TILLMAN RIDGE SUBDIVISION
15453 KARCHER ROAD, CANYON COUNTY, ID
Six Point Development
COVER SHI

Preliminary Plat Requirements Checklist (CCCO §07-17-09)

Applicant: Ackerman-Estvold	Case Number: SD2026-0001
Subdivision Name: Tillman Ridge	Plat Date: 3rd Review (Plat date 7/16/2026)
Planning Review	
Scale of Drawing (No more than 1" = 100' unless approved by DSD before submission. Size of Drawing (No larger than 24' x 36"). <i>Obtain an electronic version of all submittals.</i> (CCZO 07-17-09(1)A).	
Review Comment: Compliant. Physical and digital versions submitted. 2 nd Review: Compliant. 3rd Review: Still Compliant.	
Proposed name of the subdivision and its location by section, township, and range (CCZO 07-17-09(1)B.1).	
Review Comment: Compliant. However, the year should be updated to 2026. 2 nd review: Compliant (Sheets 3-6). 3rd review: Still Compliant.	
Name, address, and phone number of the developer (CCZO 07-17-09(1)B.3).	
Review Comment: Compliant. 2 nd Review: Still Compliant (Sheet 1 & 3). 3 rd Review: Still Compliant	
Name, address, and phone number of the person preparing the plat (CCZO 07-17-09(1)B.4).

**RE: HD4 Board of Commissioners
Tillman Ridge Subdivision
Prelim

4 TWO LANE RURAL ROAD SECTION WIDENING

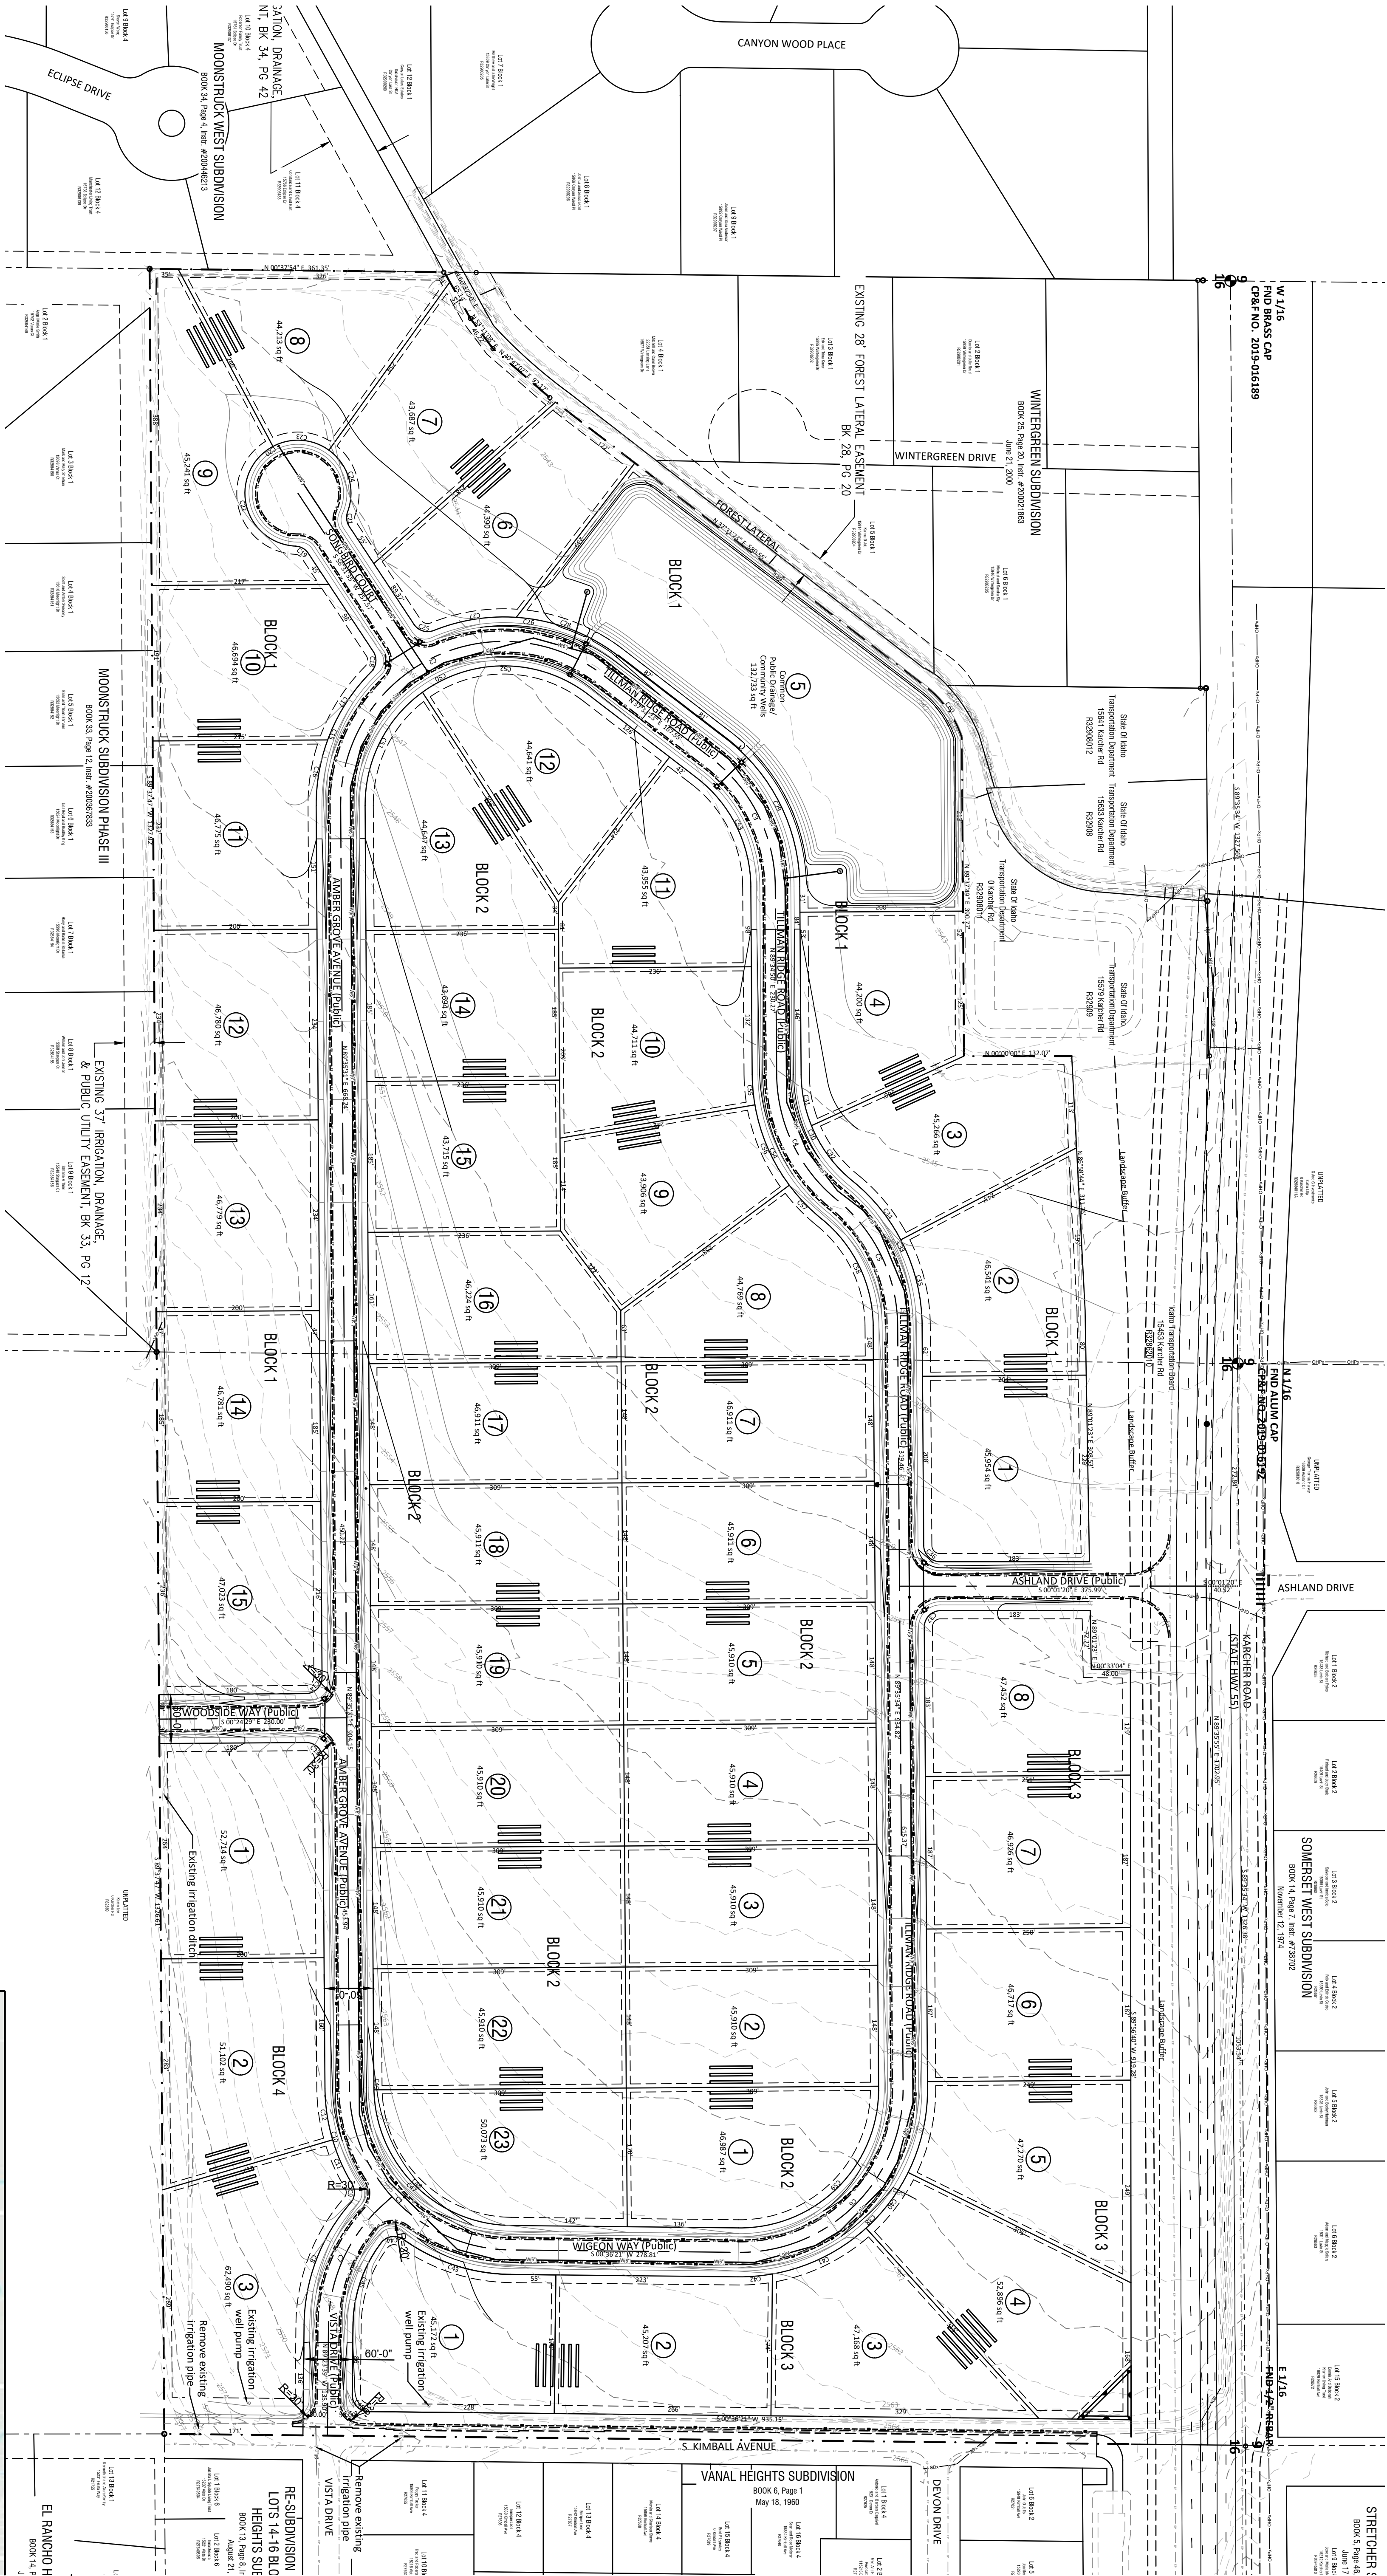
1. Revise Sheet 4, Typical section:
 - a. Remove Note E
 - b. Revise item callout #5 to specify 4:1 side slopes, (Per ACCHD-101 dwg)
 - c. Revise callout circle 4 to have leader pointing to the shoulder
 - d. Revise to add callout circle 5 to gravel borrow
2. Revise ROW dedication and improvements to begin at the south side of Vista Drive and terminate at the north property line of existing well lot. Dedication consists of ~990 LF
3. Add note on sheet 4, "Pavement design determined at time of improvement drawings"
4. Revise curve radii for EP and ROW at intersections to match policy
5. All other platting and improvement requirements to be in accordance with the current edition of the Highway Standards and Development Procedures Manual and those ACHD standards adopted for use in the City of Star in effect at the time of improvement drawing submittal.

PRELIMINARY IRRIGATION PLAN
TILLMAN RIDGE SUBDIVISION

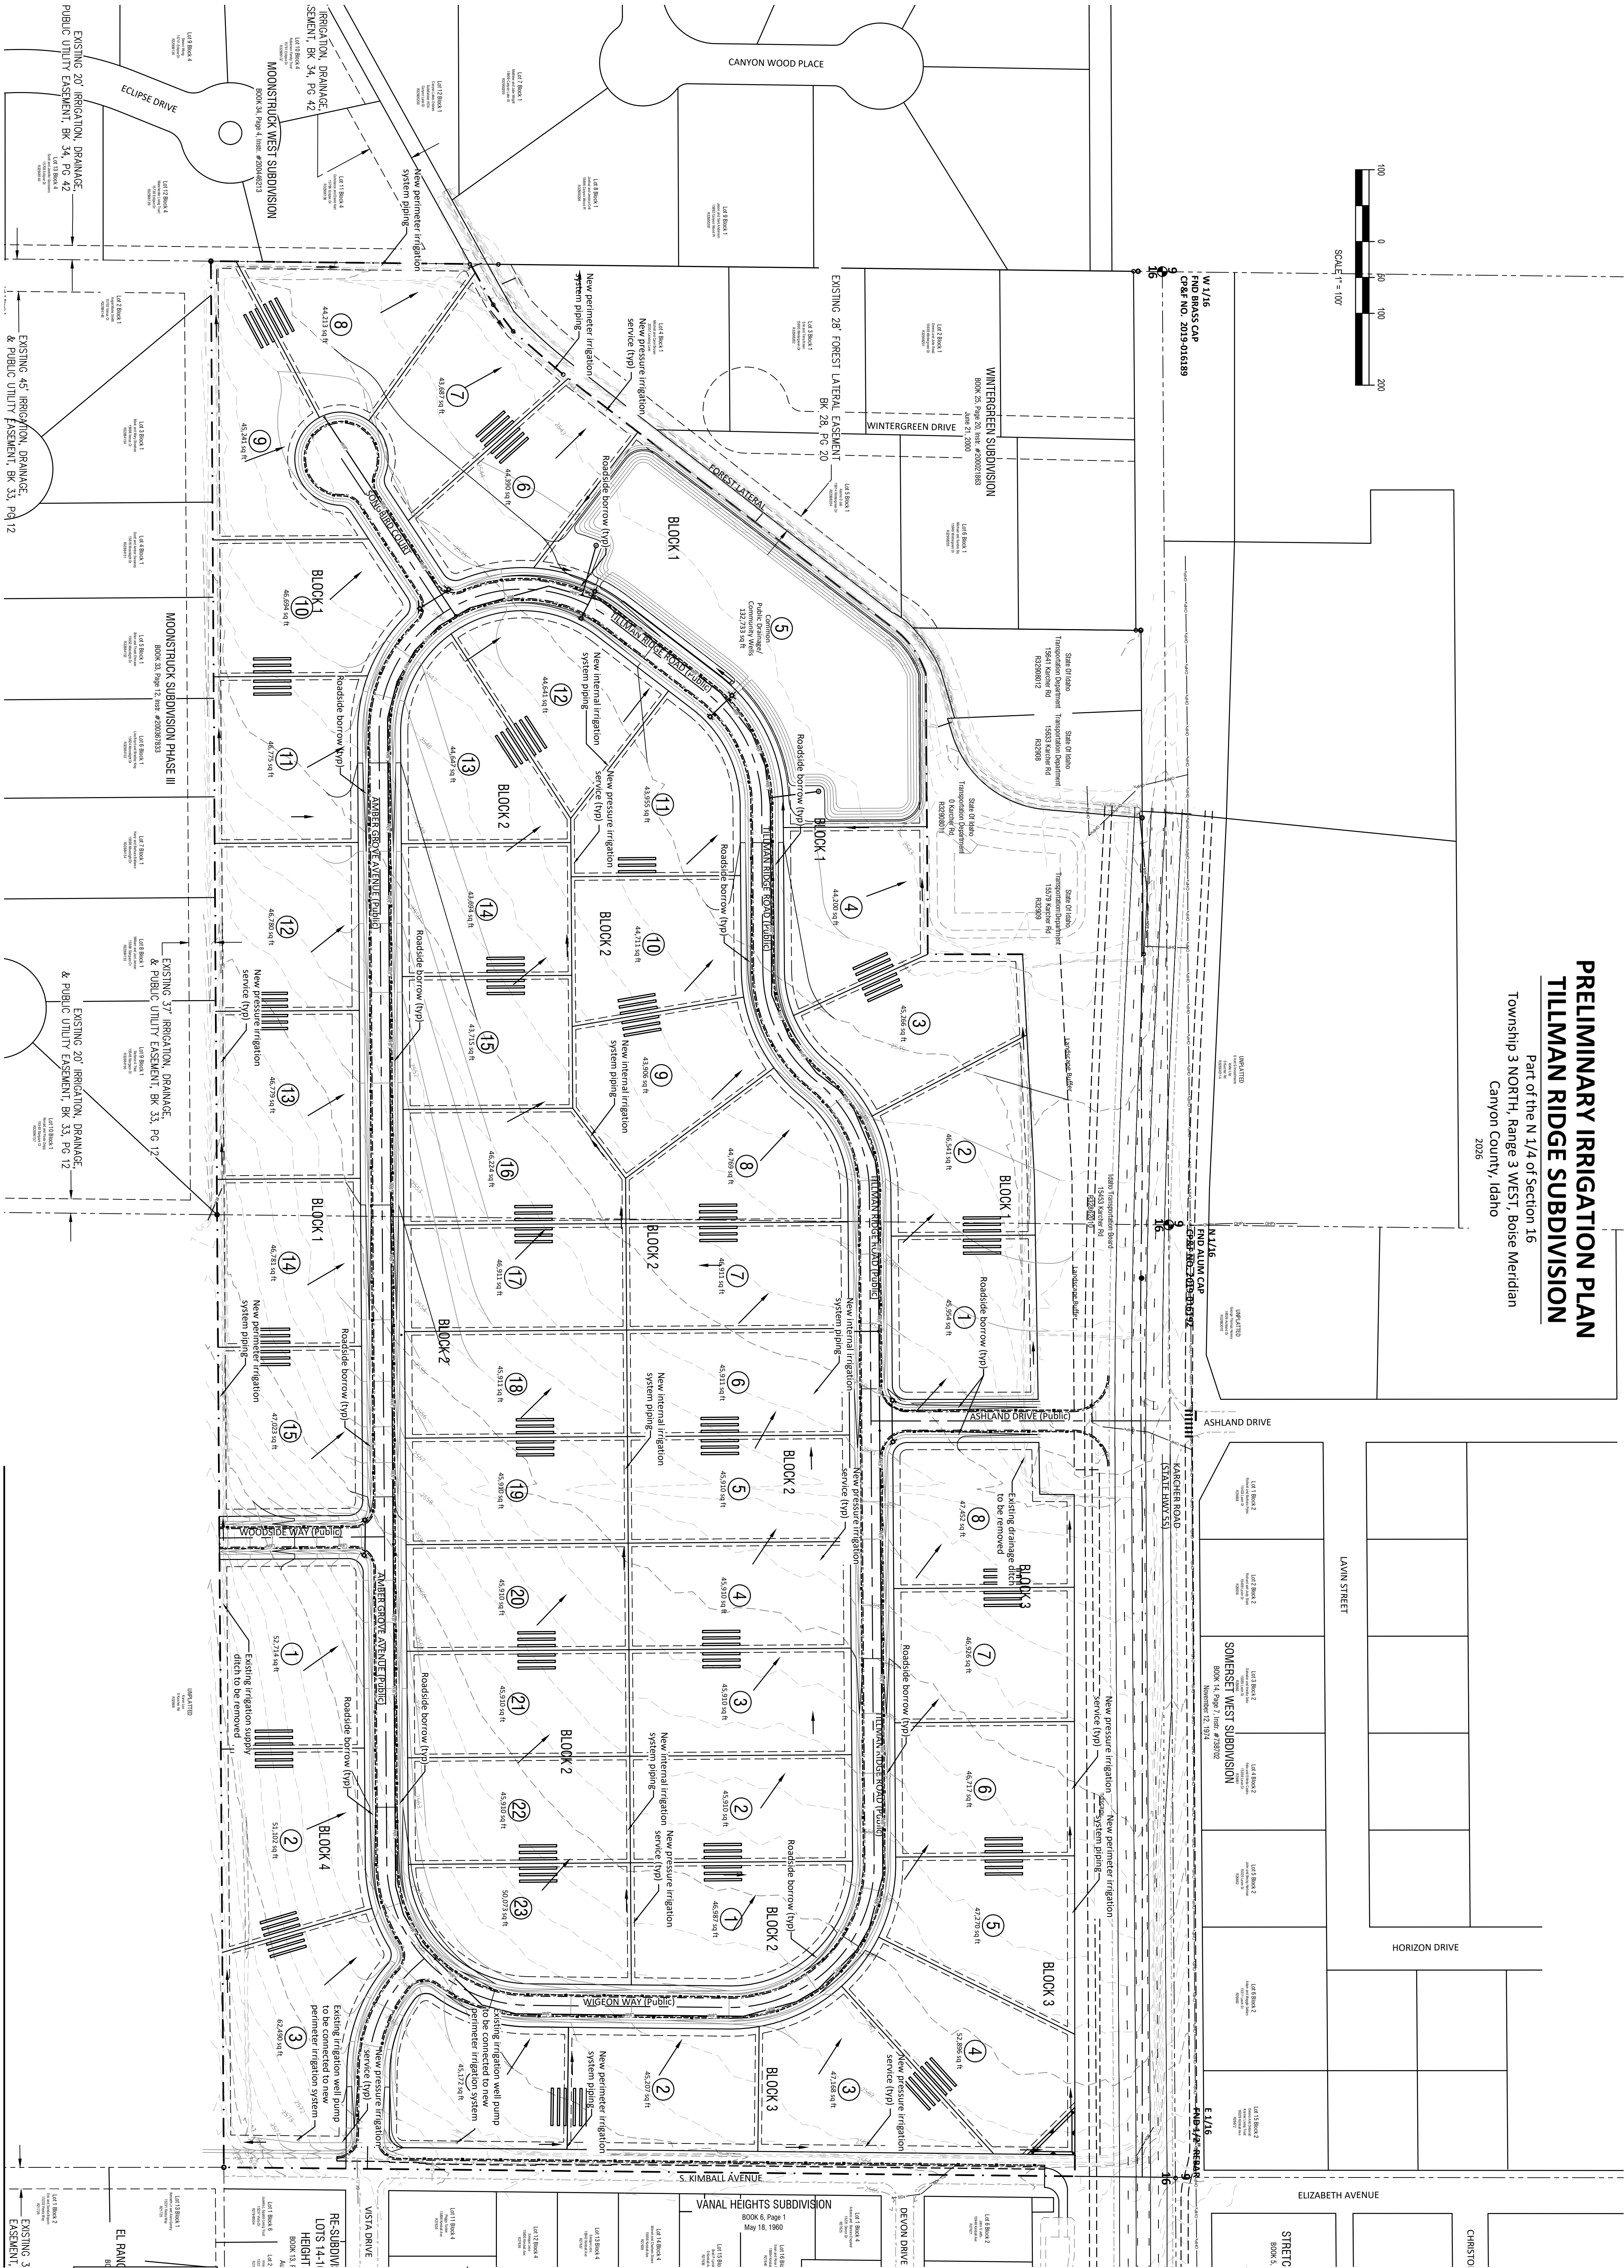
Review Comment: 2nd Review: A preliminary irrigation layout has been provided; however, additional information is required to comply with CCZO §07-17-09(1)(E)(4) and Idaho Code §31-3805. Please provide evidence that an adequate irrigation supply and distribution system will be available to serve the subdivision, including identification of applicable water rights associated with the land. Written confirmation from the irrigation provider and documentation identifying ownership, operation, and maintenance responsibility for the irrigation system shall be submitted. If applicable, provide copies of the irrigation district approval. Water Rights & Irrigation narrative showing adequate supply in submittal paperwork.

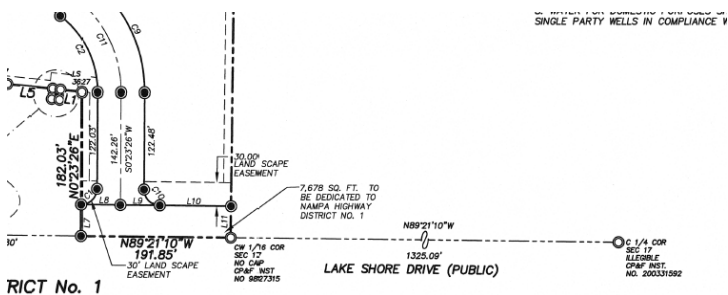
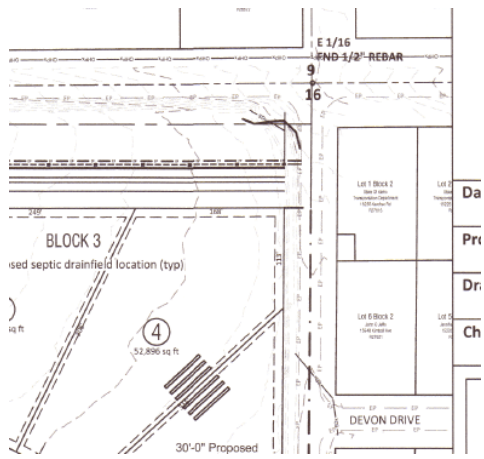
I'm not a surveyor, but simply referencing a corner does not demonstrate that the surveyor actually measured to and from that control point. Our ordinance (CCZO 07-17-09(1)B.2) requires that a bearing and distance tie from that corner to the subdivision boundary be shown on the face of the plat: "Reference by dimension and bearing to a section corner or quarter section corner."

Right now, I only see the 1/16 corner being called out.

Tillman Ridge Estates: there are no distances or bearings.

Property tied to Northeast Corner of Section 16. (Basis of Bearing) added to Call (below Lot 5 Block 2 of Summerset West Subdivision).
